V2500-A5 SERIES NACELLE SERVICE BULLETIN

This document transmits the Initial Issue of Service Bulletin NV2500-71-0295 and the Initial Issue of the Supplement

V2500-NAC-71-0295

NACELLE - POWERPLANT - CORE ENGINE - REWORK OF THE CORE FIRE DETECTOR AND THE
REROUTING OF THE FIRE DETECTION HARNESSSES

Rerouting of the Fire Detection Harness and the Core Service Harness
Figure 1 (Sheet 1 of 5)

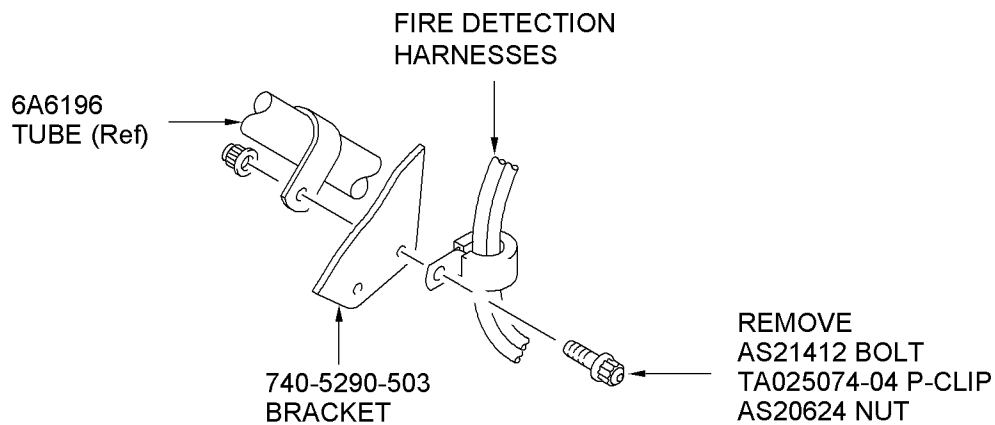
- NOTE: Make sure that the Harnesses are correctly routed. Refer to Figure 1, sheet 1.
- (15) At Clipping Point CP6078, install the Fire Detection Harnesses with the AS62504 P-Clip, the 4W0116 Bolt, the K8831 Washer, the UP10481 Spacer and the AS20624 Nut. Torque the Nut to 20 - 25 lbf in. (2 - 3 Nm). Refer to Figure 1, view F.

**CP6120
BEFORE**

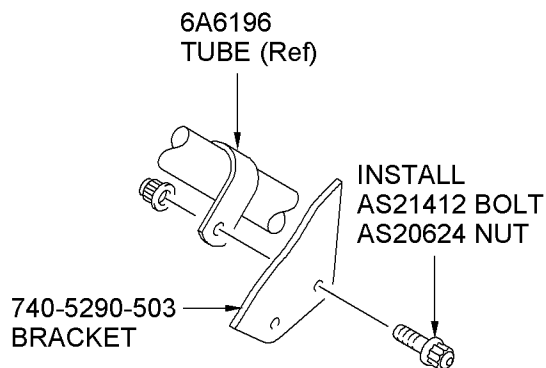
- (1) At Clipping Point CP6120, remove the AS20624 Nut, the AS21412 Bolt and the TA025074-04 P-Clip to release the Fire Detection Harness from the 740-5290-503 Bracket. Refer to Figure 1, view B.

- (2) Install the 740-5290-503 Bracket to the 6A6196 Tube with the AS21412 Bolt and the AS20624 Nut. Torque the Nut to 20 - 25 lbf in. (2 - 3 Nm).
- (3) Disconnect the 4001WD1-A Electrical Connector and the 4001WD2-A Electrical Connector from the Fire Detector. Refer to Figure 1, view D.

Rerouting of the Fire Detection Harness and the Core Service Harness
Figure 1 (Sheet 2 of 5)

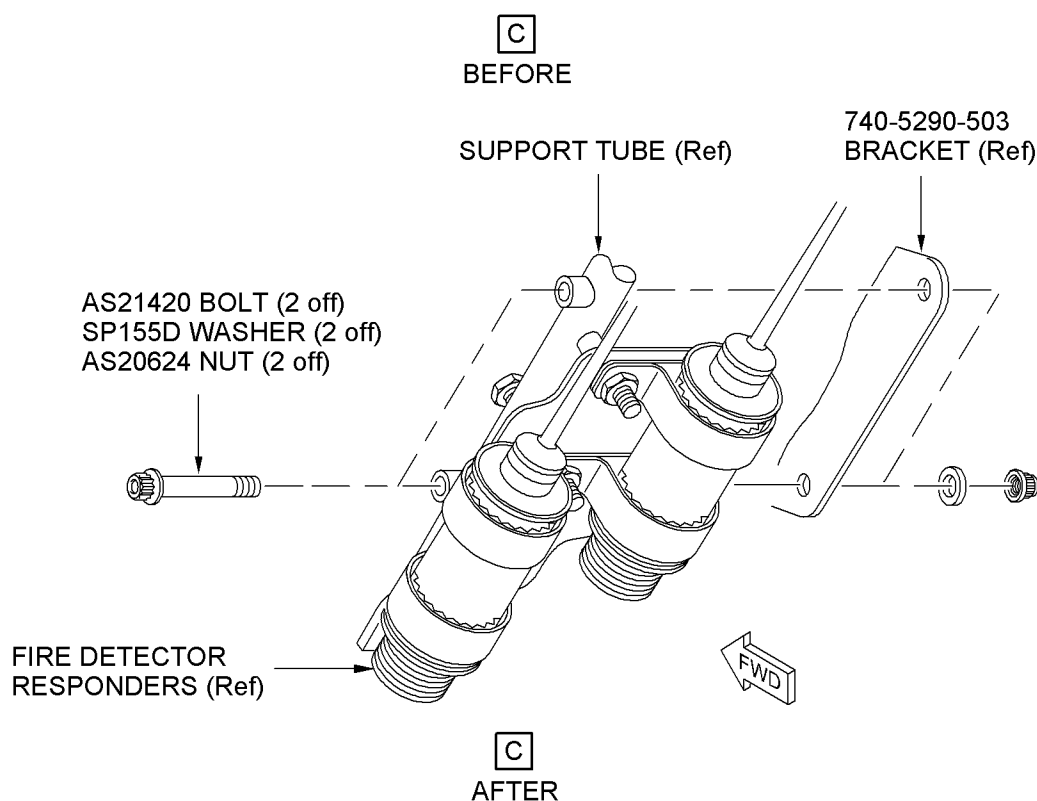
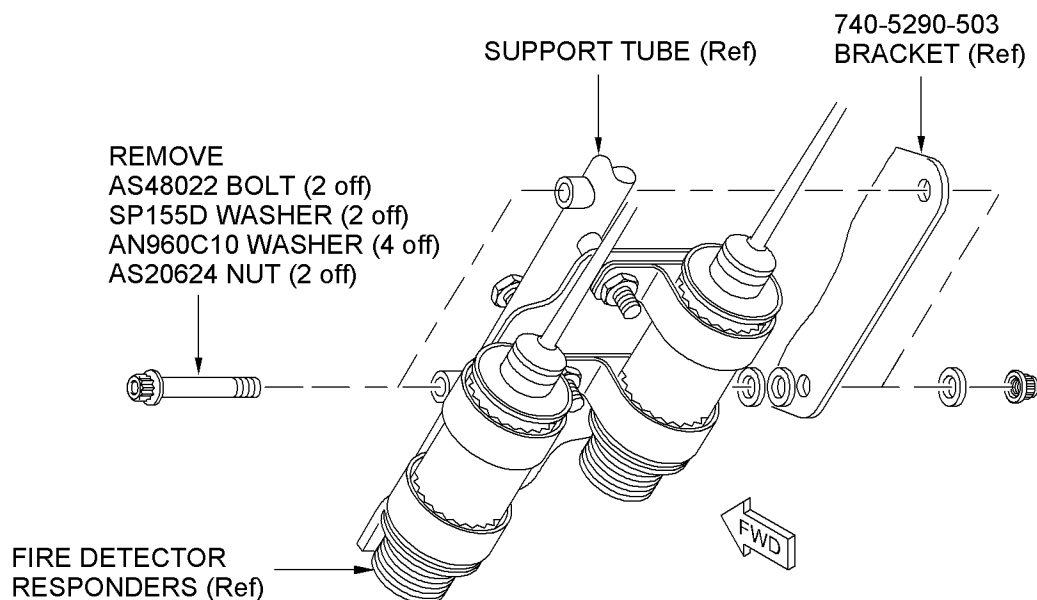
- (4) Install the applicable covers/caps/plugs to the electrical connectors and electrical receptacles.
- (5) At two locations, remove the AS20624 Nut, the SP155D Washer, the two AN960C10 Washers and the AS48022 Bolt to release the Support Tube from the 740-5290-503 Bracket. Refer to Figure 1, view C.

- (6) At two locations, install the Support Tube to the 740-5290-503 Bracket with the AS21420 Bolt, the SP155D Washer and the AS20624 Nut. Torque the Nut to 20 - 25 lbf in. (2 - 3 Nm).

Rerouting of the Fire Detection Harness and the Core Service Harness
Figure 1 (Sheet 3 of 5)

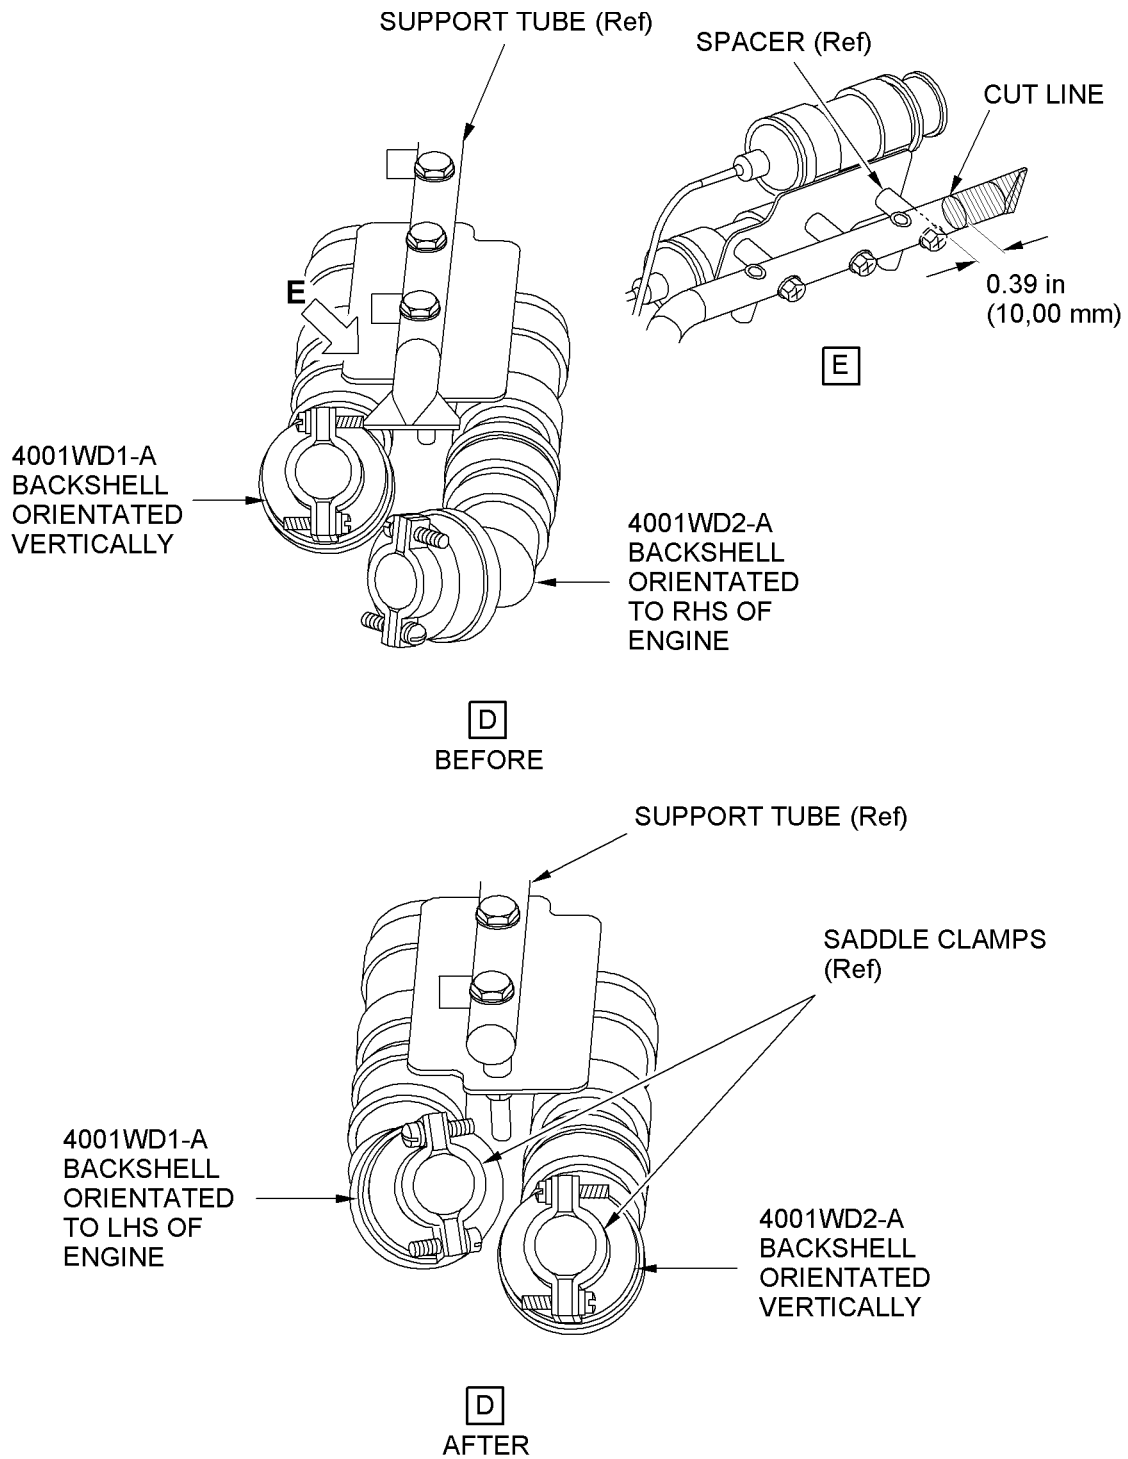
- (7) For operators with Meggitt Fire Detection Systems, rework the 7827-02 Meggitt Fire Detector as follows:
 - (a) Make a mark of the cut line on the Fire Detector Support Tube. Refer to Figure 1, view E.

- (b) Use a tube cutter to remove the end of the Support Tube. Make sure that you do not damage adjacent hardware. If necessary, remove the Fire Detector as instructed in the Aircraft Maintenance Manual, Task 26-12-17-000-010.

- (c) Deburr the cut metal edges of the Tube.
 - (d) Use a vibro-etcher to re-identify the Fire Detector to 7827-03 on the support tube near to the existing 7827-02 marking.

Rerouting of the Fire Detection Harness and the Core Service Harness
Figure 1 (Sheet 4 of 5)

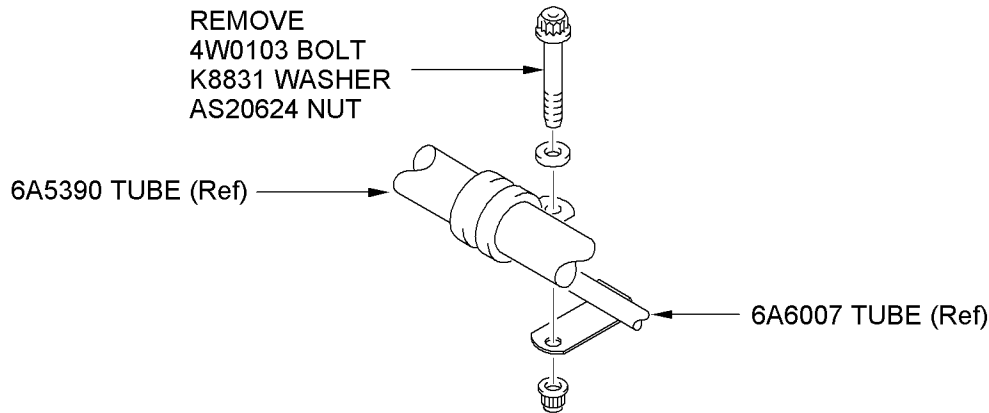
- (9) Clock the 4001WD1-A Electrical Connector on the 745-5861-509 Fire Detection Harness to achieve maximum clearance. Refer to Figure 1, view D.
- NOTE: To clock the 4001WD2-A Electrical Connector correctly, looking on the plug face, set the major keyway of the connector at the 9 o'clock position when the backshell is at the 12 o'clock position.

- NOTE: To clock the 4001WD1-A Electrical Connector correctly, looking on the plug face, set the major keyway of the connector at the 4 o'clock position when the backshell is at the 12 o'clock position.

- NOTE: To achieve maximum clearance with adjacent hardware set the saddle clamps of the 4001WD1-A Electrical Connector at approximately the 12 o'clock position.

Rerouting of the Fire Detection Harness and the Core Service Harness
Figure 1 (Sheet 5 of 5)

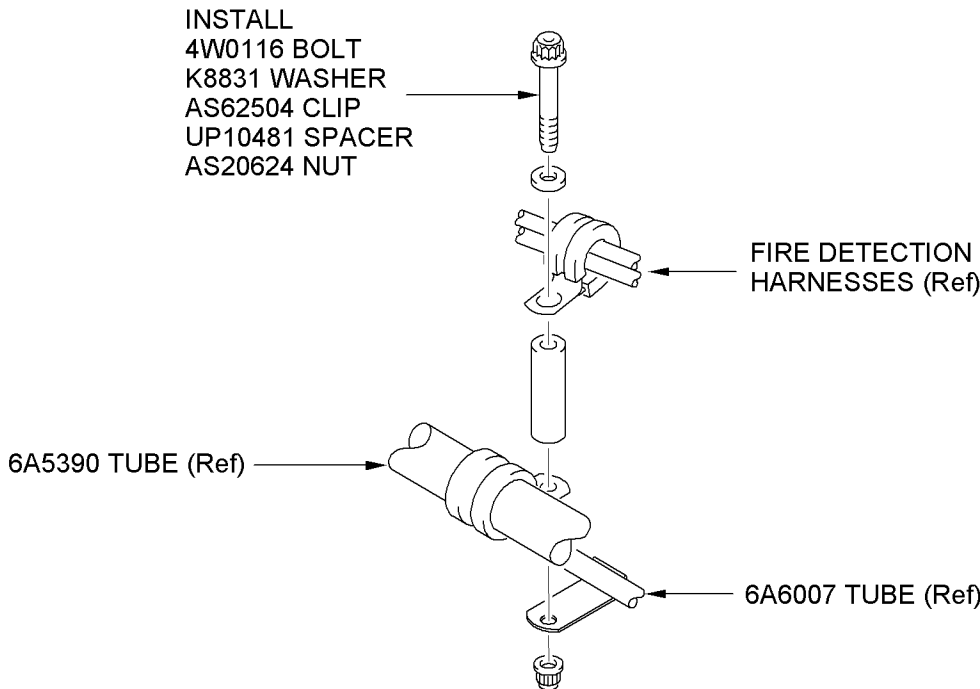
- (14) At Clipping Point CP6078, remove the AS20624 Nut, the K8831 Washer and the 4W0103 Bolt. Refer to Figure 1, view F.
- NOTE: Distribute the slack in the Harness to prevent stress loads on the Harness Connectors.
